**SERVICE BULLETIN**

**N° 139-559**

**ATA 71 - FIREWALLS RETROMOD**

This Service Bulletin is issued in order to provide the necessary instruction to reinforce the firewalls by performing the installation of the firewalls retro modifications P/N 3G7130P01411 and P/N 3G7130P01412.

**Figure 8**

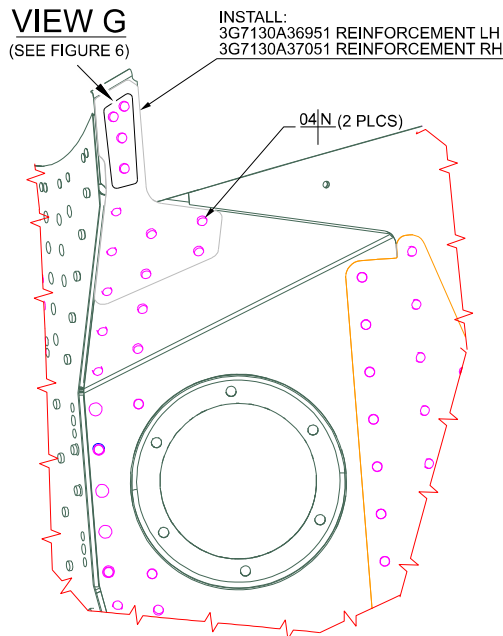
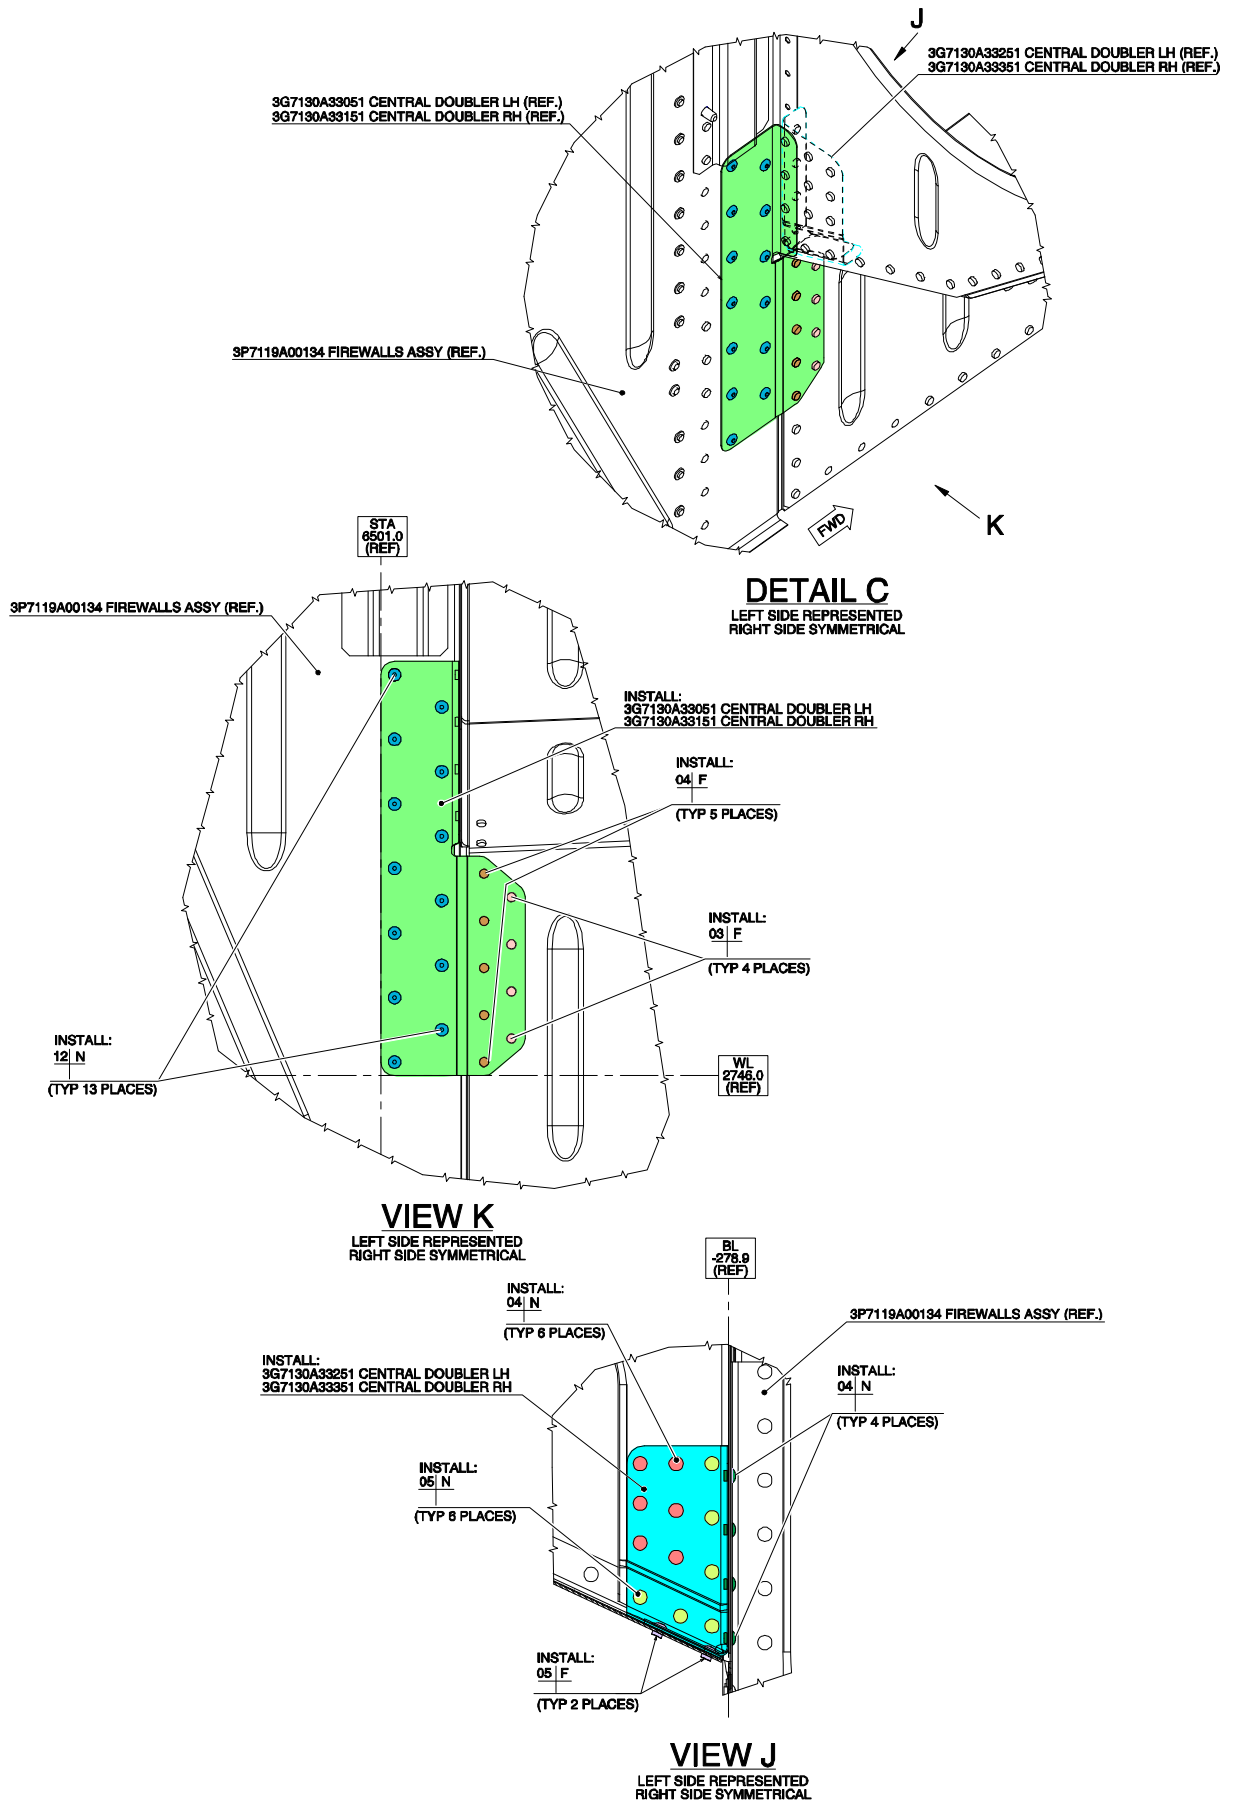
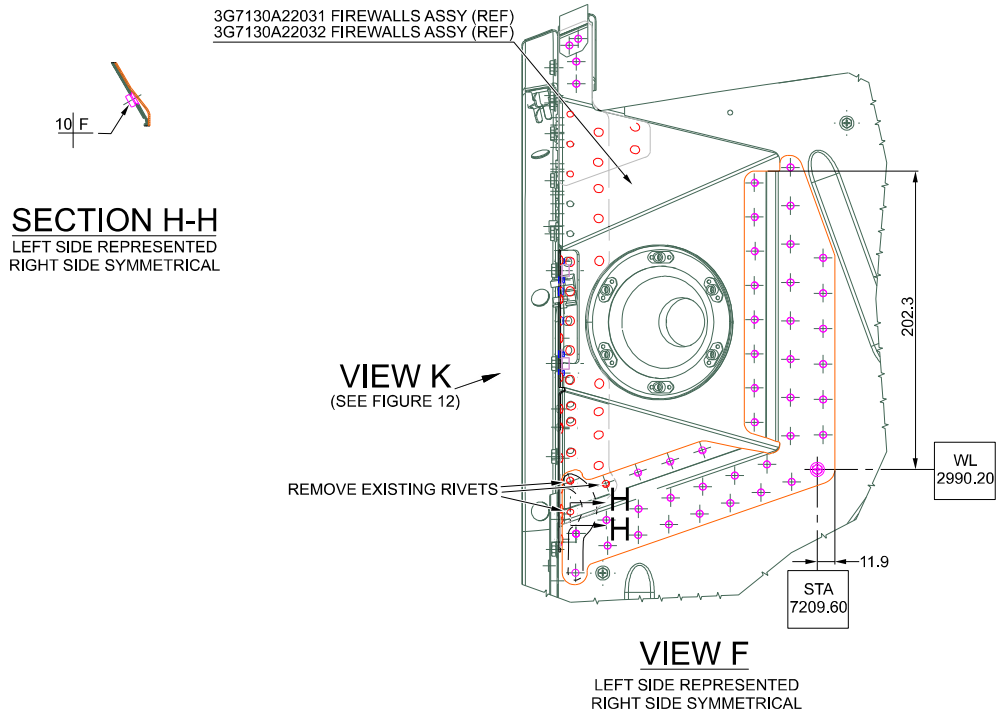
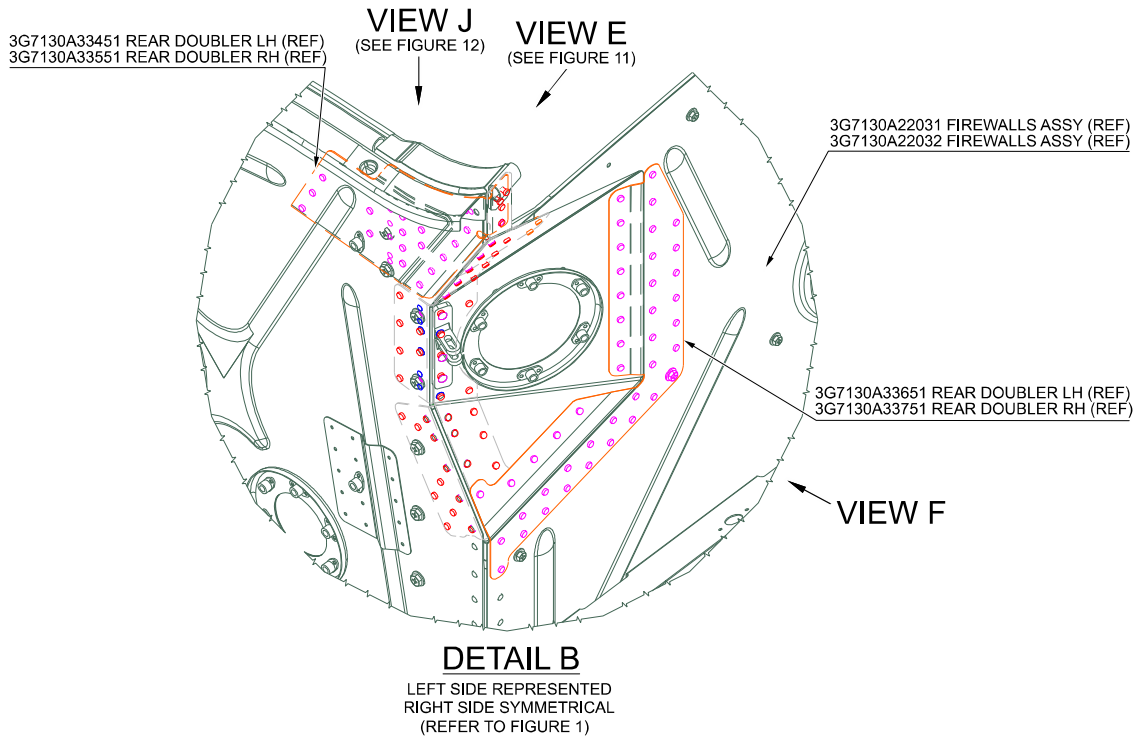
- 2.14 With reference to Figure 8 view J, temporarily remove the left upper connector P/N 3P7119A31752 and the existing rivets.
- 2.15 With reference to Figure 8 view J, remove the connector P/N 3G7130A29651 and the existing rivets. Retain for later reuse the n°2 anchor nuts P/N MS21069L3K.

- 2.16 With reference to Figure 8 view J, remove the left lower connector P/N 3P7119A31351 and the existing rivets.

- 2.21 With reference to Figure 8 view J and view K, temporarily locate the reinforcement LH P/N 3G7130A36751 and the reinforcement LH P/N 3G7130A36951 on the drawpiece LH P/N 3P7119A25752 and countermark the necessary rivet holes.

- 2.22 With reference to Figure 8 view J and view K, drill the necessary rivet holes thru the drawpiece LH P/N 3P7119A25752 on the previously countermarked positions.

- 2.23 With reference to Figure 4 view F and section H-H and Figure 8 view J and K, install the rear doubler LH P/N 3G7130A33651, the reinforcement LH P/N 3G7130A36751, the reinforcement LH P/N 3G7130A36951 and re-install the left upper connector P/N 3P7119A31752 by means of n°36 rivets P/N MS20615-4M4, n° 8 rivets P/N NAS1200-4-4 and the rivet P/N NAS1200-4-3.

- 2.24 With reference to Figure 8 view J, re-install the n°2 anchor nuts P/N MS21069L3K by means of n°4 rivets P/N MS20427M3-4-5 on the reinforcement LH P/N 3G7130A36751.

**Figure 12**

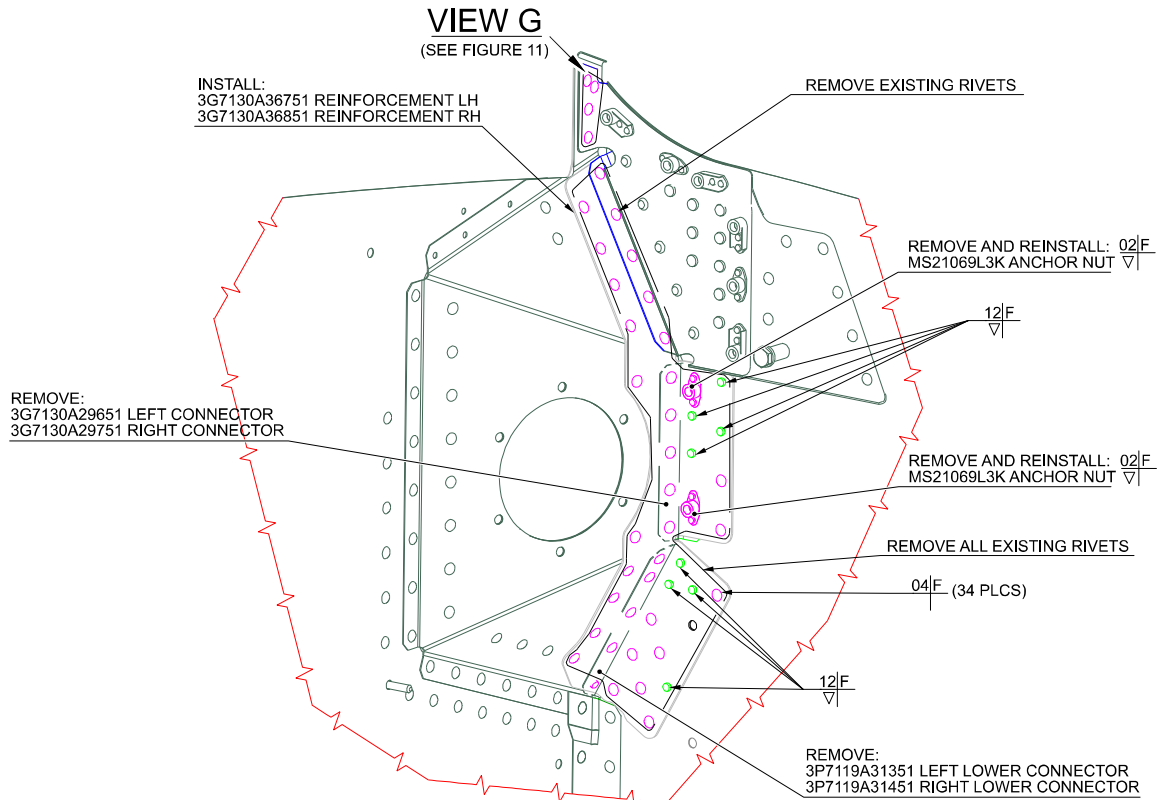
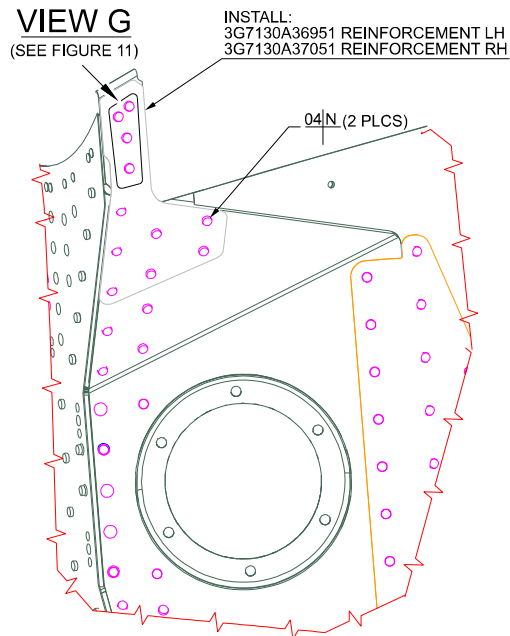
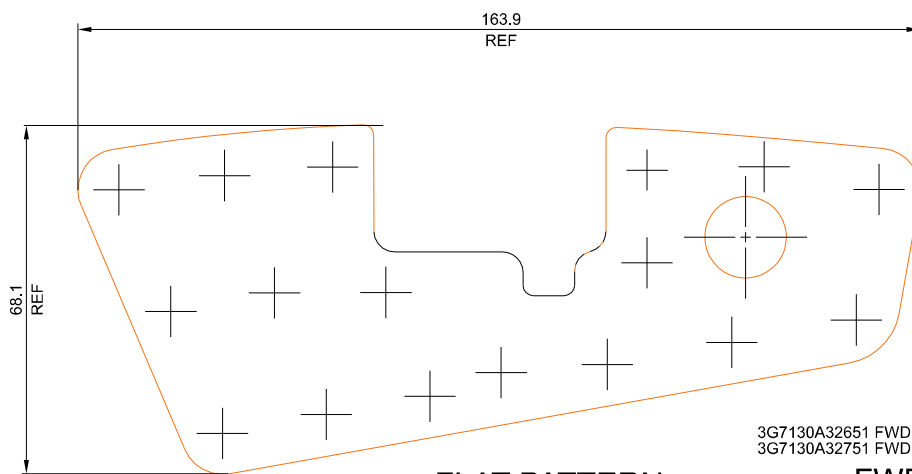
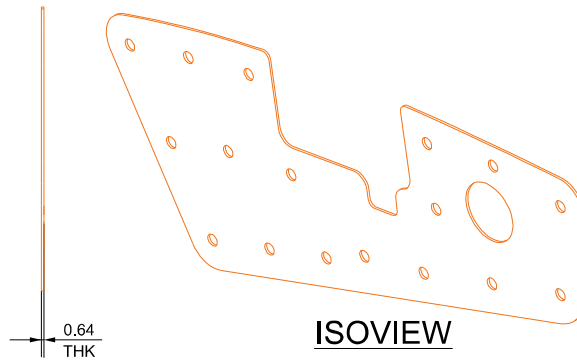
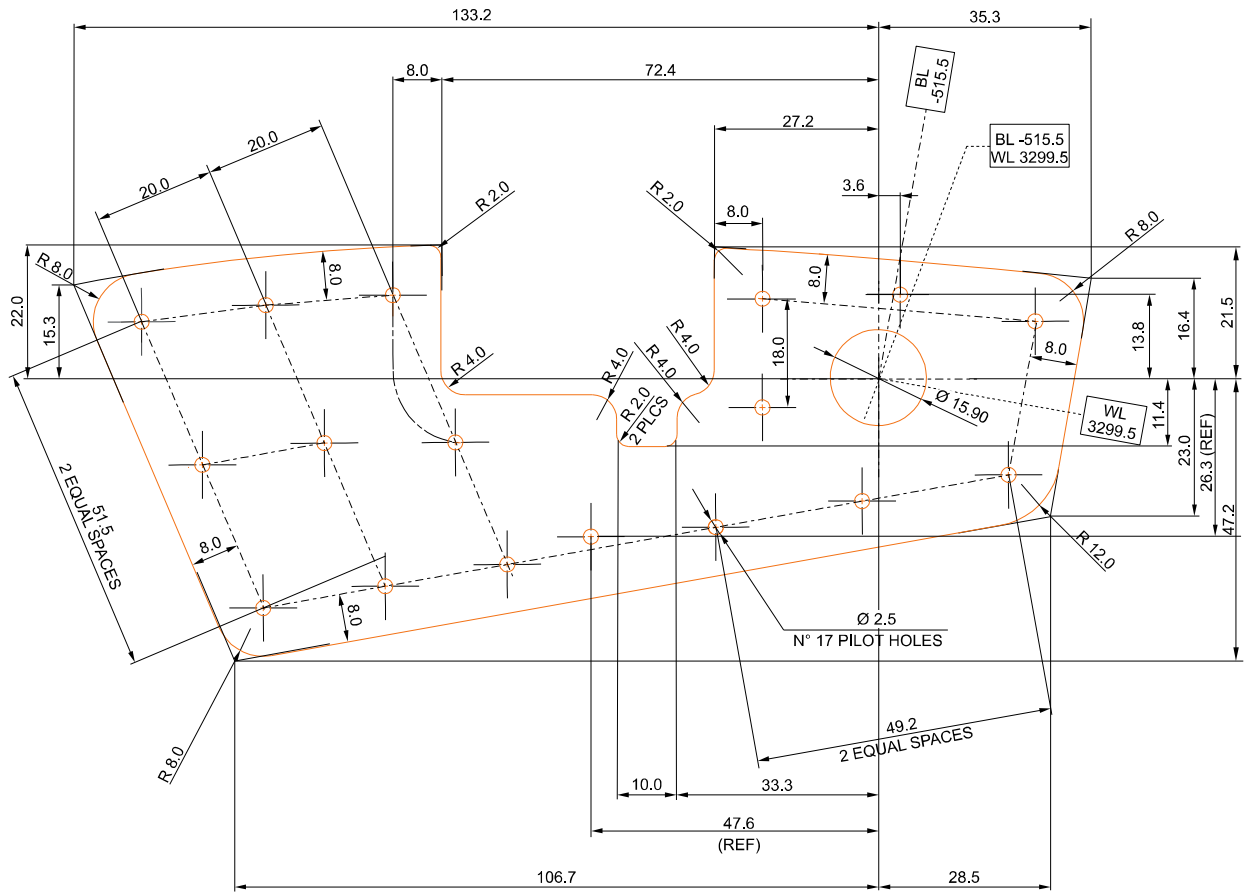
- 2.3 With reference to Figure 12 view J, remove and discard five existing from the left upper connector P/N 3P7119A31752.
  - 2.4 With reference to Figure 12 view J, remove the connector P/N 3G7130A29651 and the existing rivets. Retain for later reuse the n°2 anchor nuts P/N MS21069L3K.

- 2.5 With reference to Figure 12 view J, remove the left lower connector P/N 3P7119A31351 and the existing rivets.
  - 2.6 With reference to Figure 12 view J and view K, temporarily locate the reinforcement LH P/N 3G7130A36751 and the reinforcement LH P/N 3G7130A36951 on the drawpiece LH P/N 3P7119A25752 and countermark the necessary rivet holes.

- 2.7 With reference to Figure 12 view J and view K, drill the necessary rivet holes thru the drawpiece LH P/N 3P7119A25752 on the previously countermarked positions.

- 2.8 With reference to Figure 10 view F and section H-H and Figure 12 view J and view K, install the reinforcement LH P/N 3G7130A36751 and the reinforcement LH P/N 3G7130A36951 by means of n°36 rivets P/N MS20615-4M4, n° 8 rivets P/N NAS1200-4-4 and the rivet P/N NAS1200-4-3.

- 2.9 With reference to Figure 12 view J, re-install the n°2 anchor nuts P/N MS21069L3K by means of n°4 rivets P/N MS20427M3-4-5 on the reinforcement LH P/N 3G7130A36751.
